NEW YORK CITY DEPARTMENT OF CORRECTION

**ADDENDUM #4 PIN 072202009CPD**

**George R. Vierno Center (GRVC) State of Good Repair**

**DESCRIPTION OF CHANGES**

DRAWING NO.

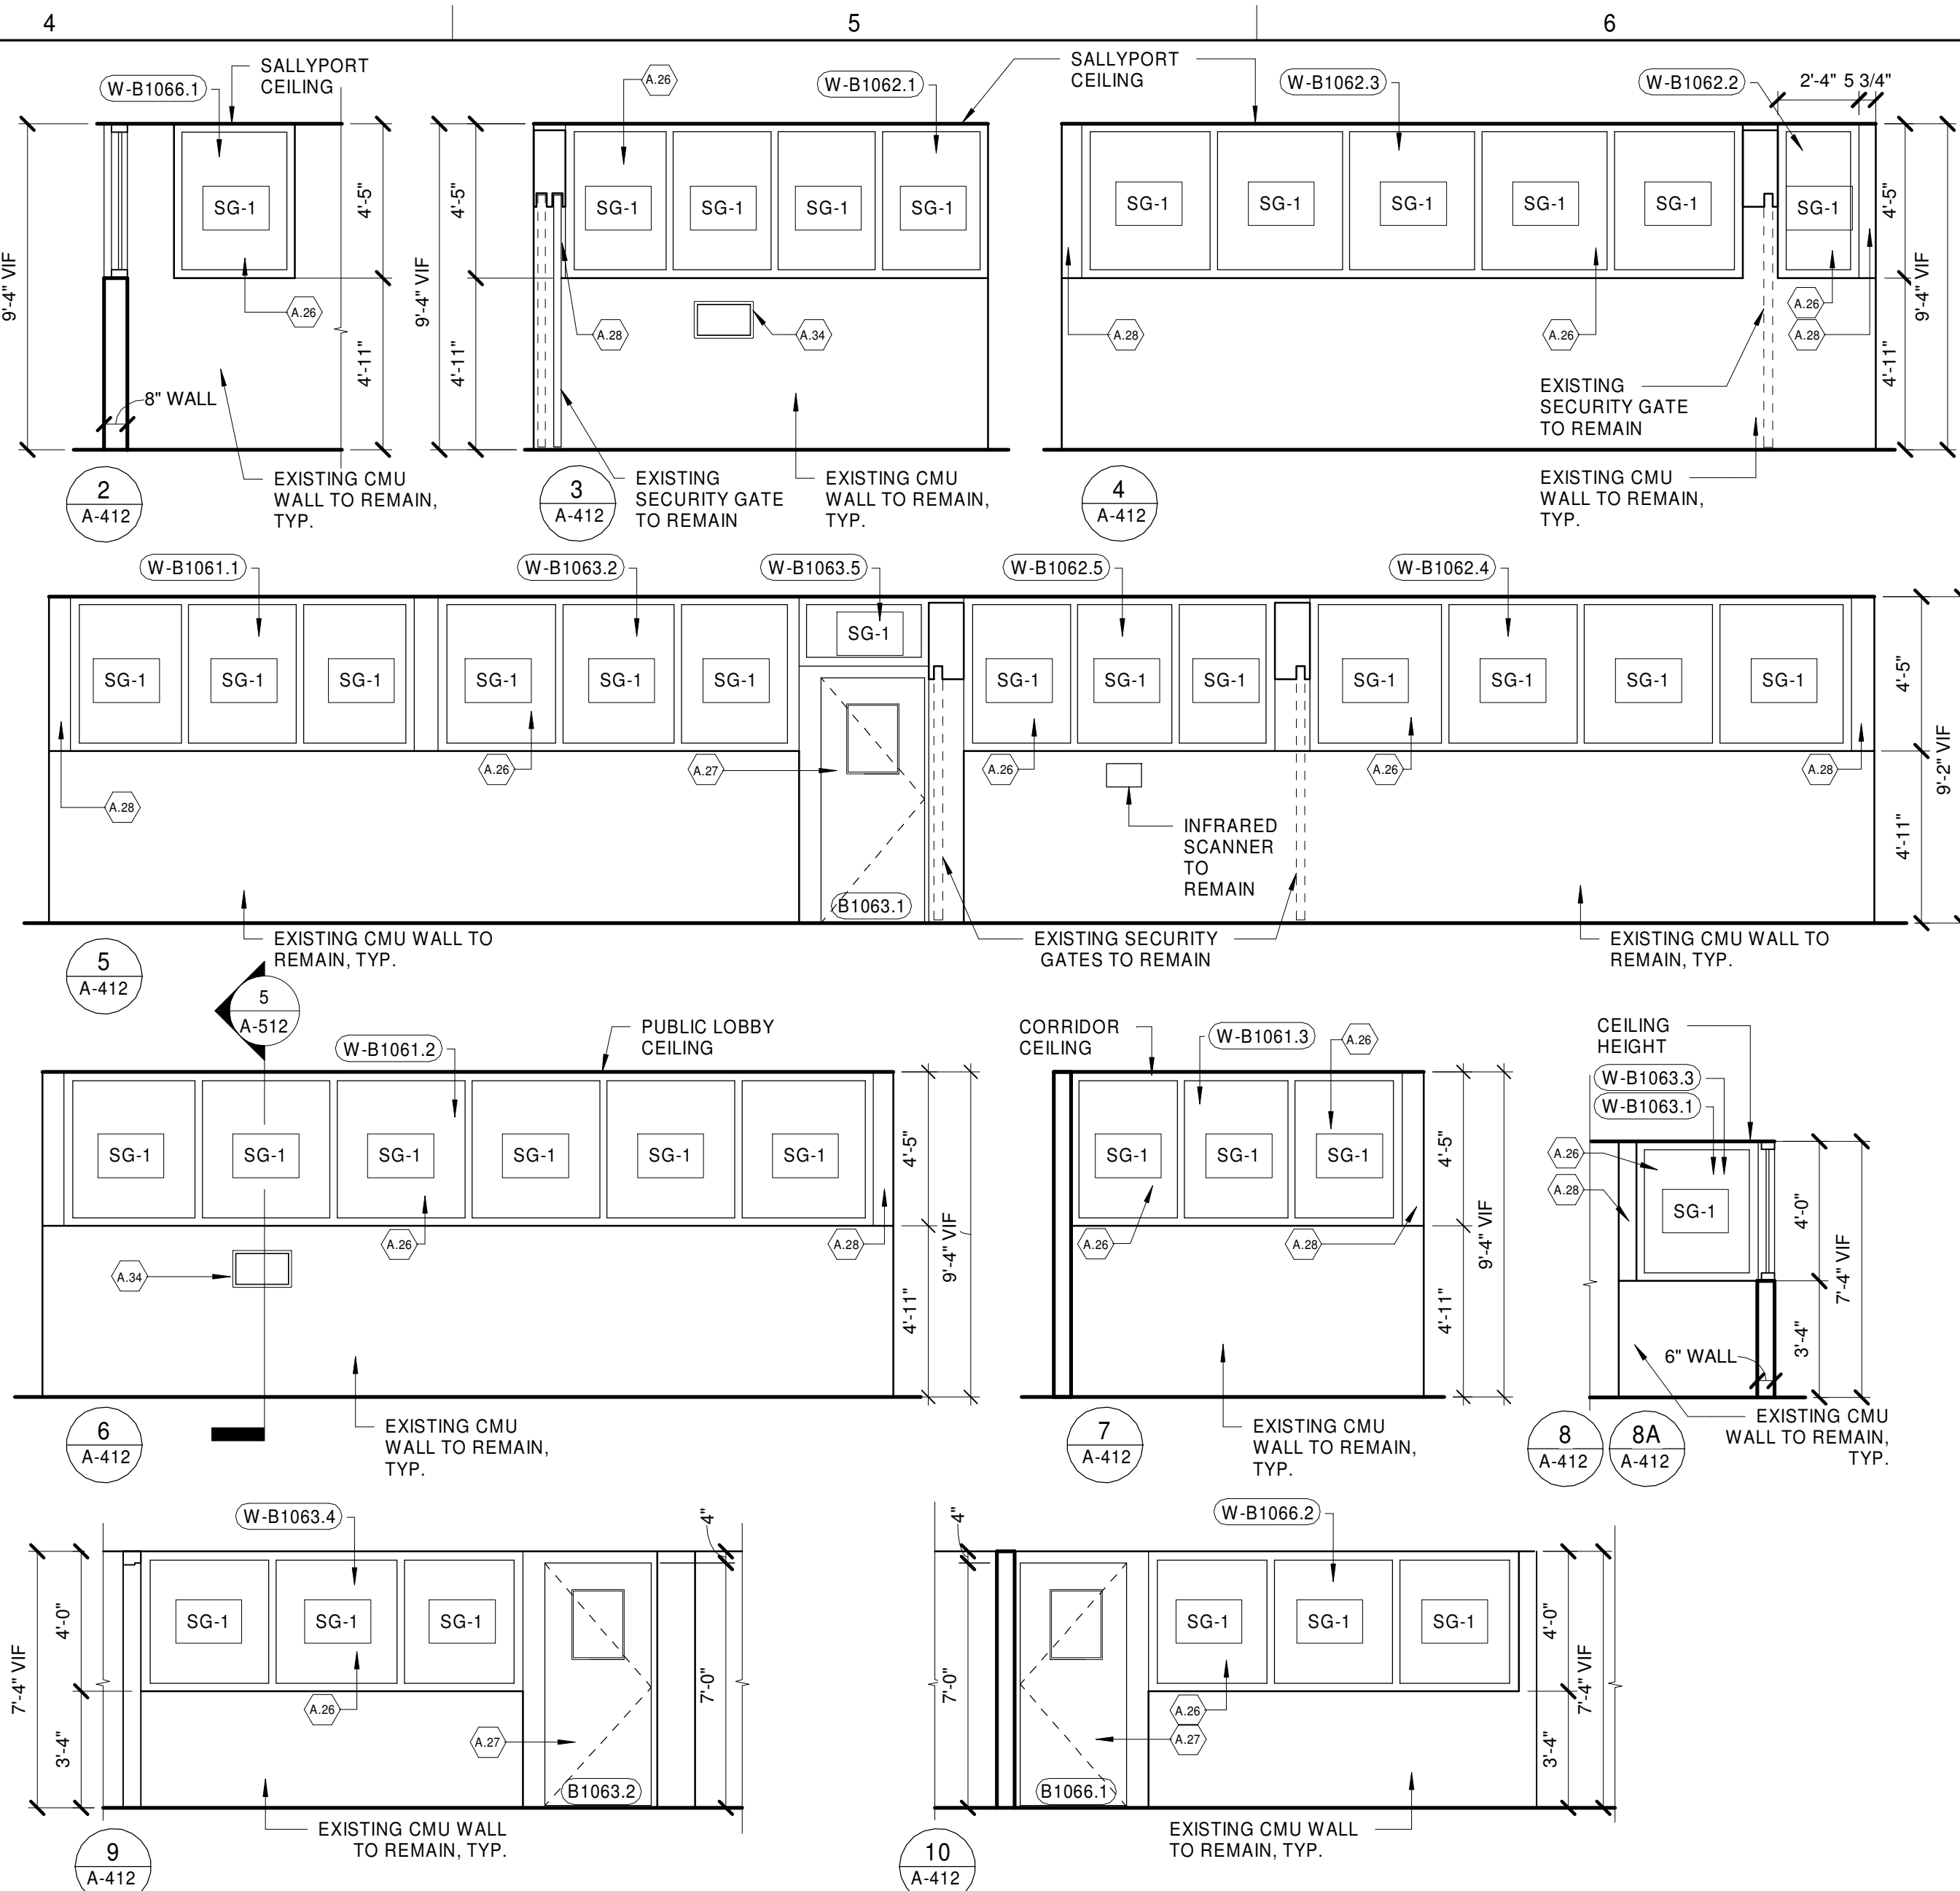
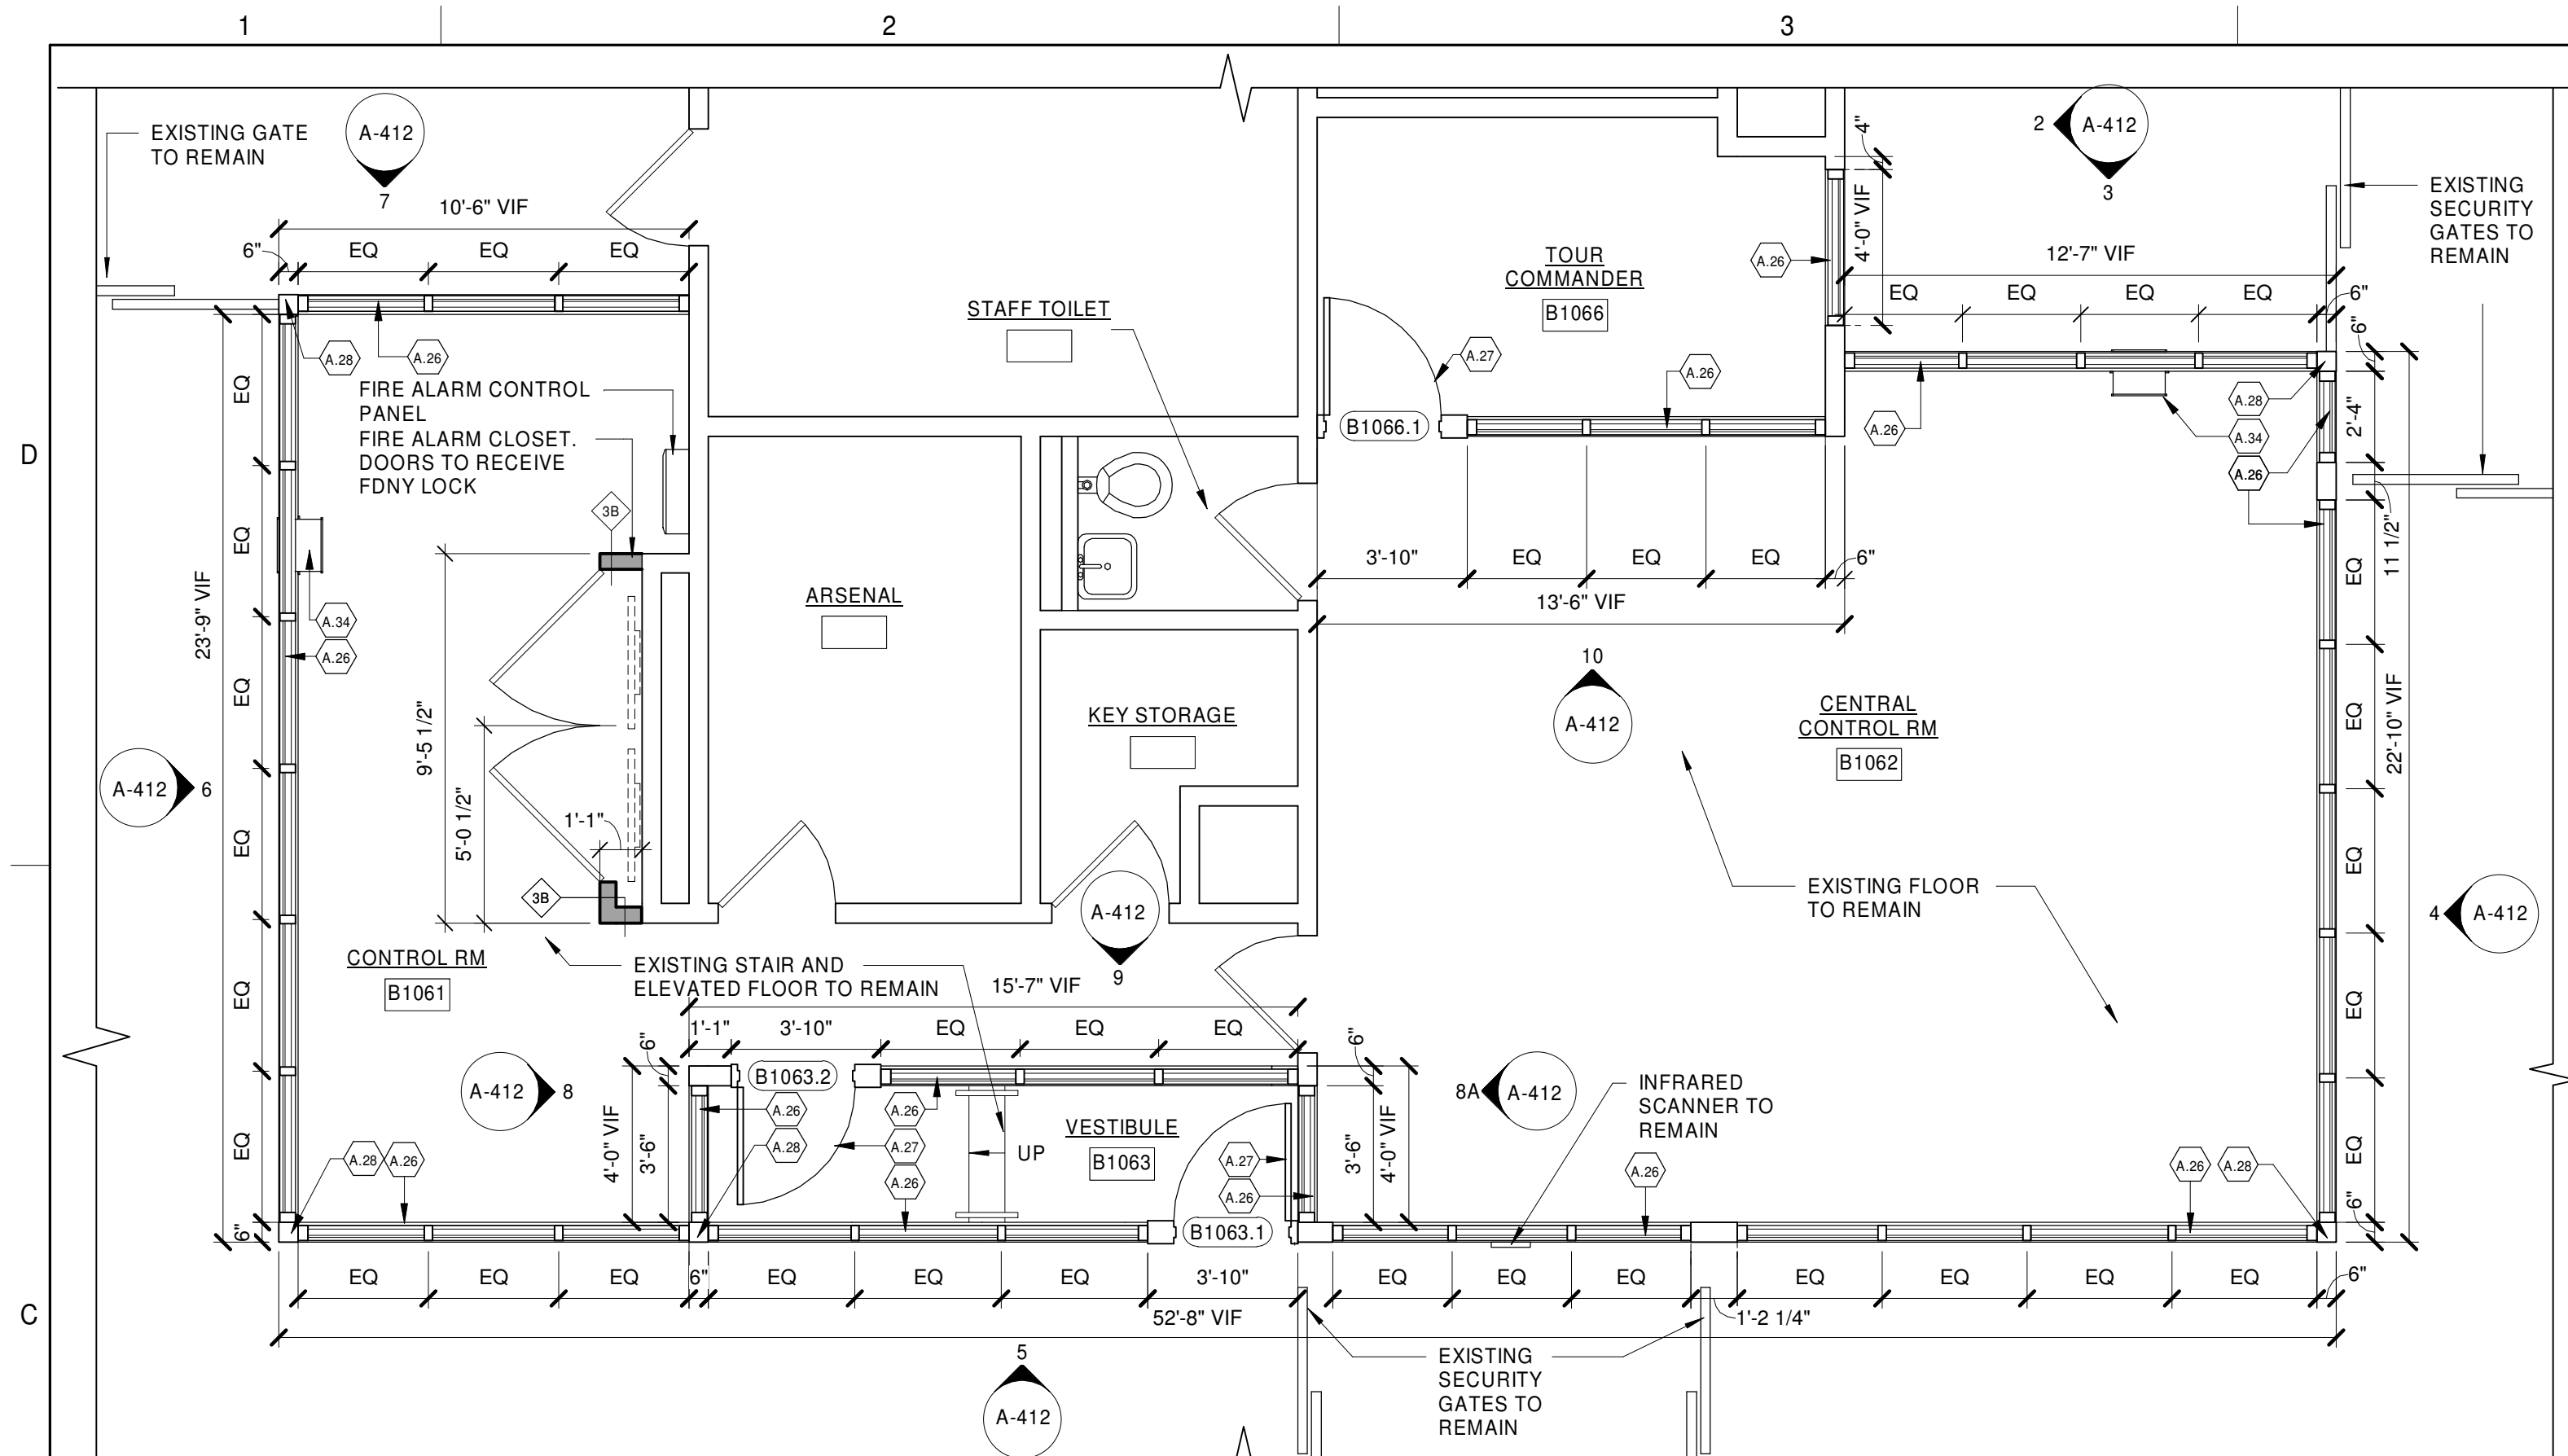
3. **A-320.00:** Added Mesh Infill Panels at the Roof Guardrail on the Parapet Sections.
4. **A-411.00:** Revised Keynote #A.26.
5. **A-412.00:** Revised Keynote #A.26.

**FA-146.00**

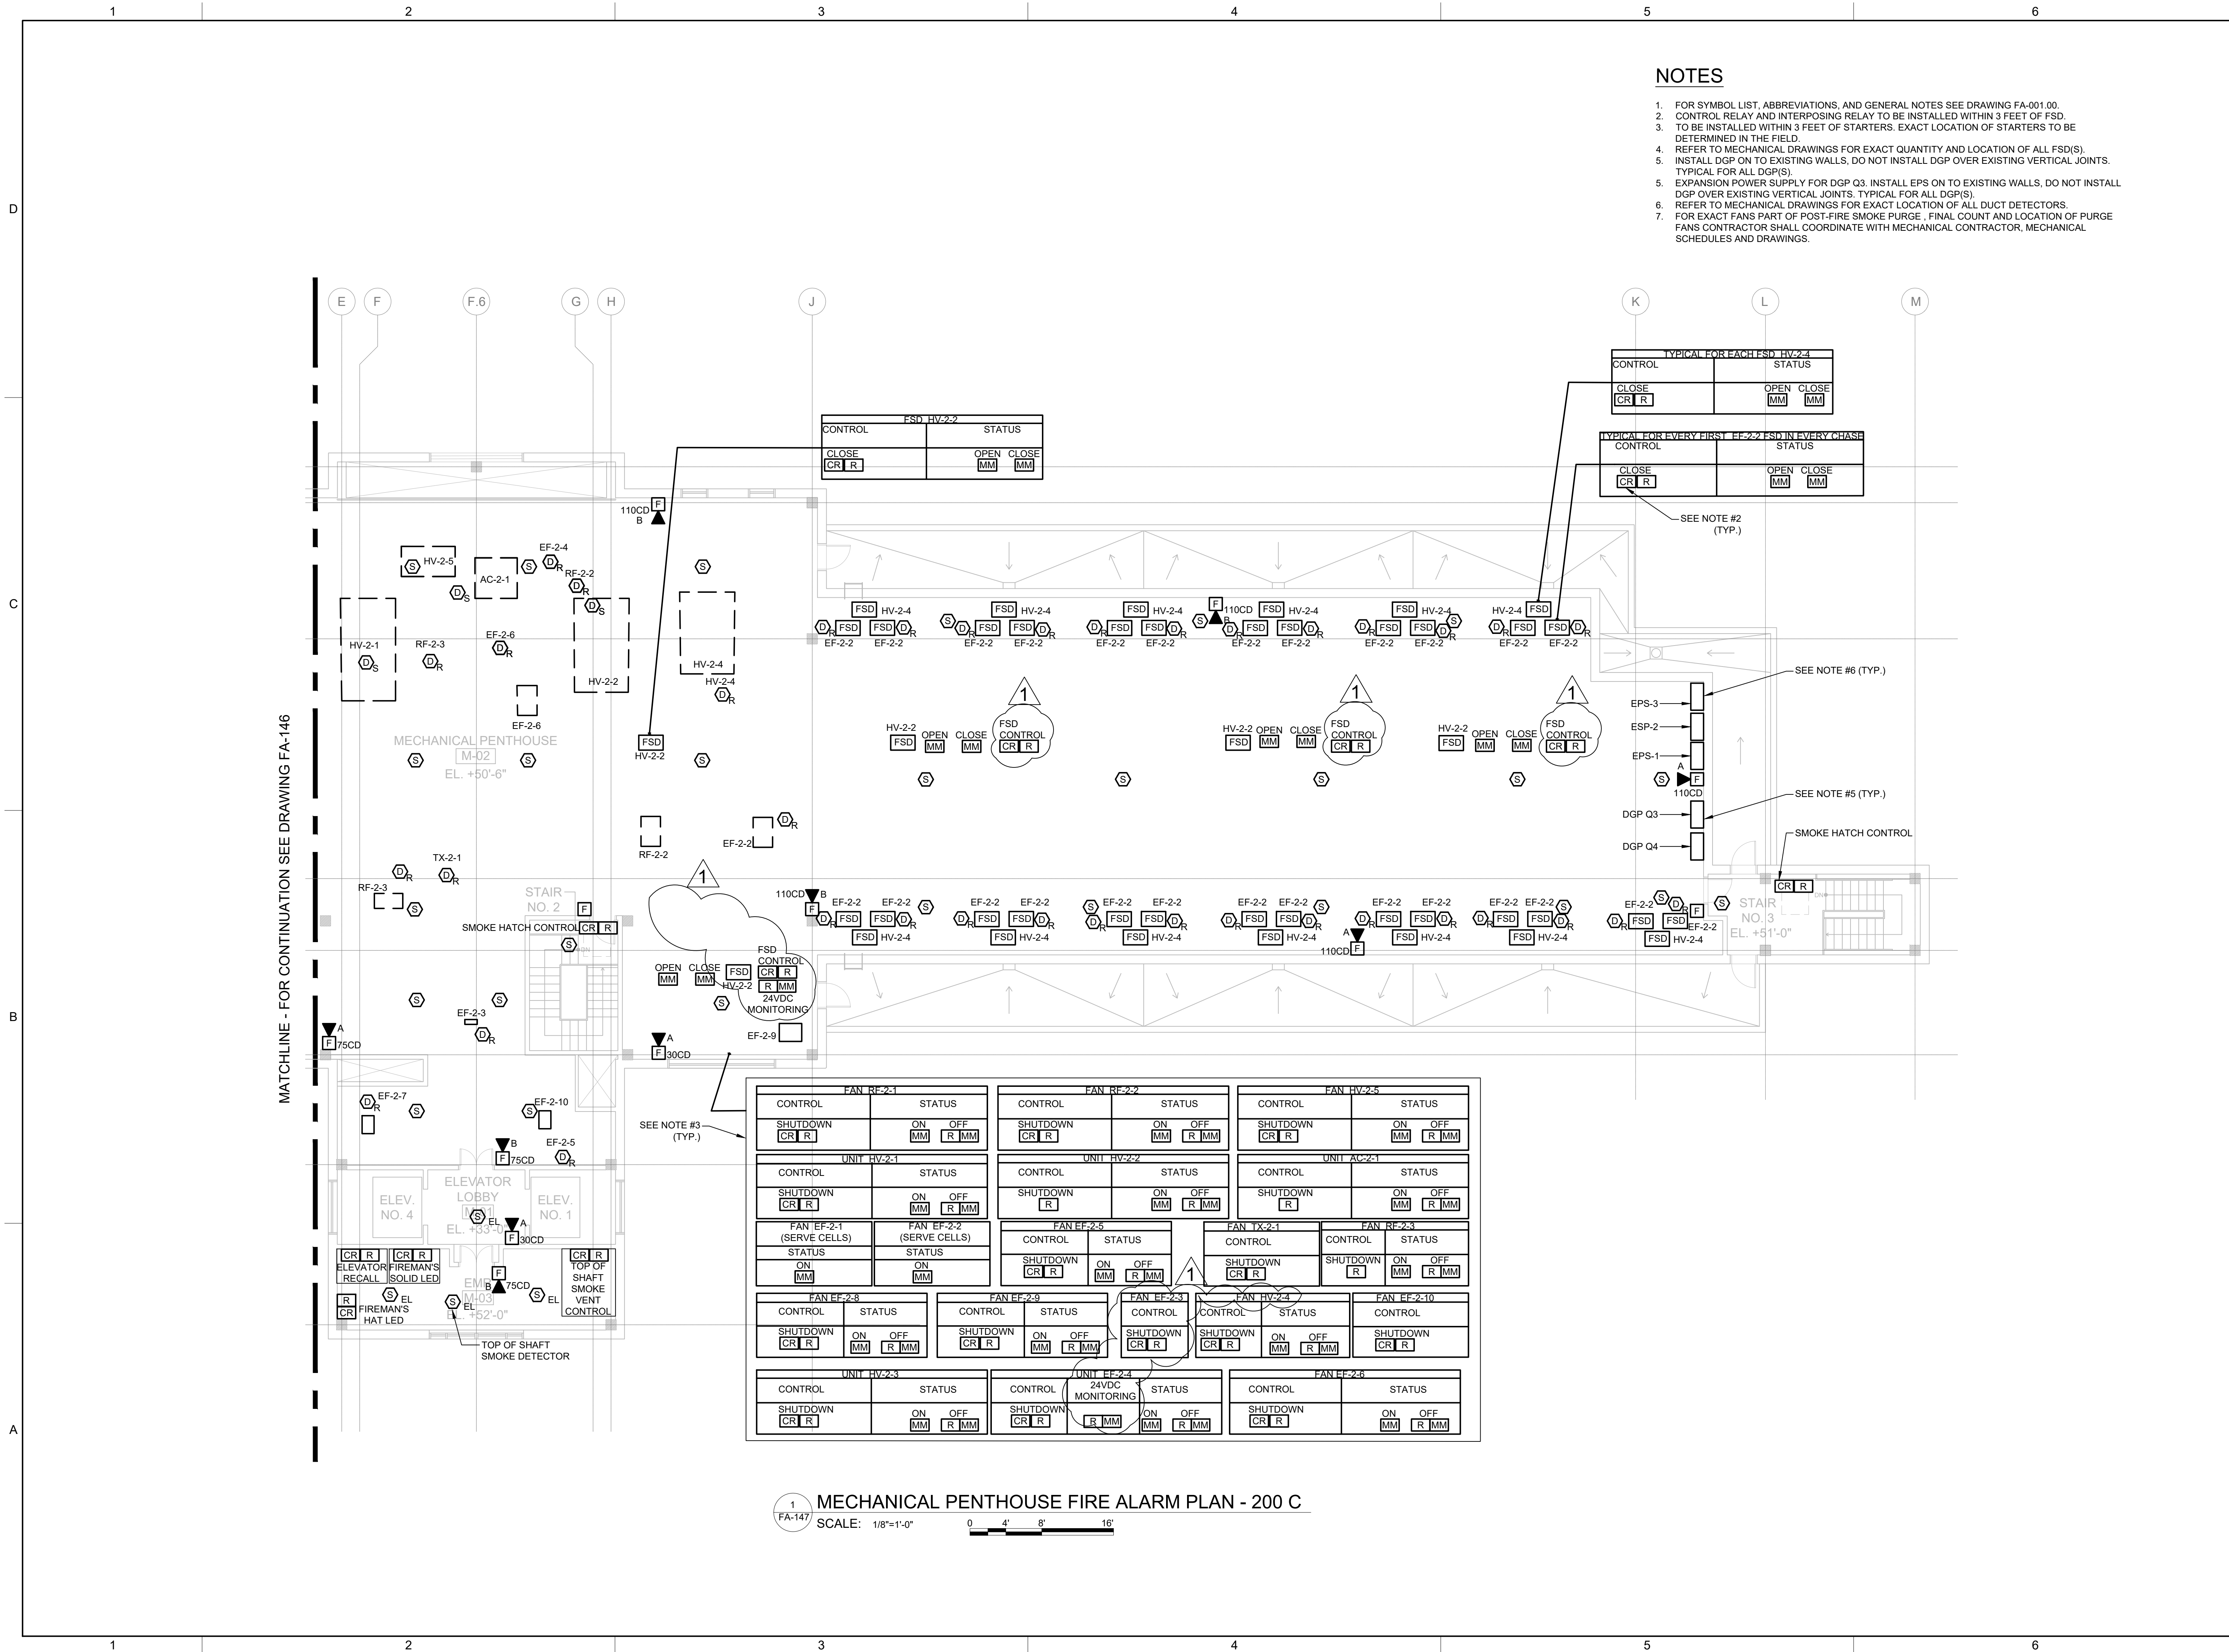
14. **FA-146.00:** Added Control Shutdown Relays for FSD Control
15. **FA-147.00:** Added Control Shutdown Relays for an Exhaust Fan Unit and deleted a pair of Monitoring Modules for an HVAC Unit
